Re: ACTION RE: PRELIMINARY APPROVAL OF PETITION FROM LAKESHORE DEVELOPMENT, LLC. – REQUESTING PLANNED DEVELOPMENT DISTRICT ON PARCELS AL-1148 & AL-1148-1, LOCATED AT 2550 S. WEBSTER AVENUE

ALLOUEZ SENIOR CONDOMINUM APARTMENTS

Preliminary PDD Review - Staff Comments

2550 S. Webster Avenue (Parcel AL-1148 & AL-1148-1)

PROPOSED SITE LAYOUT BILL JOHNSON VILLAGE OF ALLOUEZ, WI.

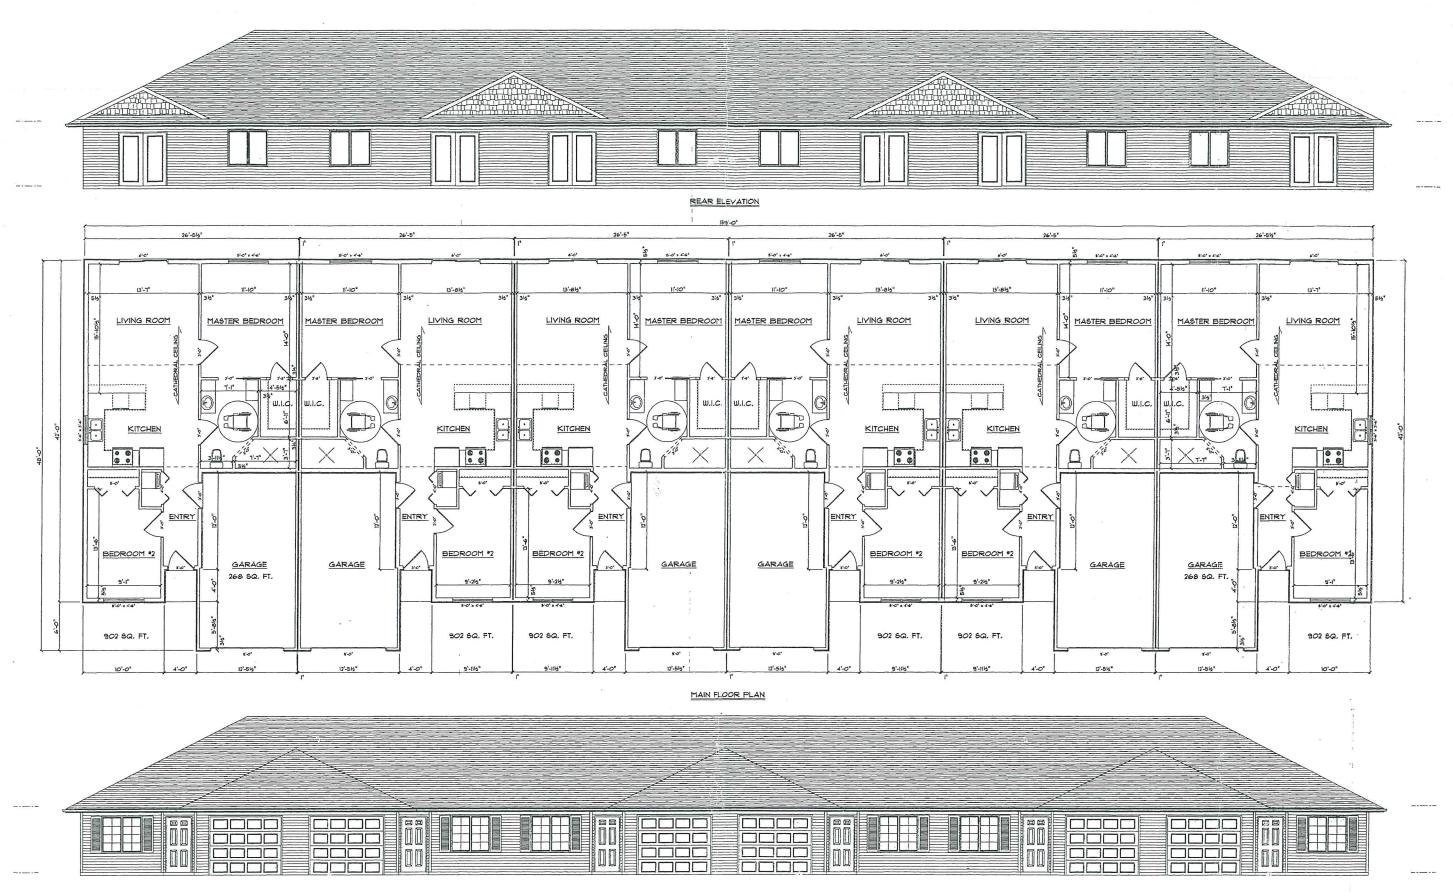
- The use and site plan are dense for new development in the area, stipulations should be clearly stated in the condominium bylaws, regarding the age of the permanent residents, number of permanent residents allowed per condo unit, and the length of stay permitted for non-permanent residents.

- The use is an allowed and existing use in the surrounding properties.
 - The setback is closer than what is allowed in the appropriate zoning district for the proposed use, but smaller setbacks are called for in the Comprehensive Plan.

- The massing of the buildings should be broken up by architectural variations in the building.
 - Pedestrian access to the buildings should be provided with facilities separate from the drive lanes (i.e. an ADA compliant sidewalk).

- Green space and parking may be inadequate.
 - Should the drive configuration meet GBMFD and Public Works standards, portions of the existing right of way will need to be vacated prior to a building permit being issued.

- The location of the trash enclosure should be identified. The trash enclosure should be screened using the same masonry materials used in primary structures.

- The parking lot and apparatus roads shall meet the minimum weight and turning radius for GBMFD apparatus (attached).
- Items to keep in mind for final approval:
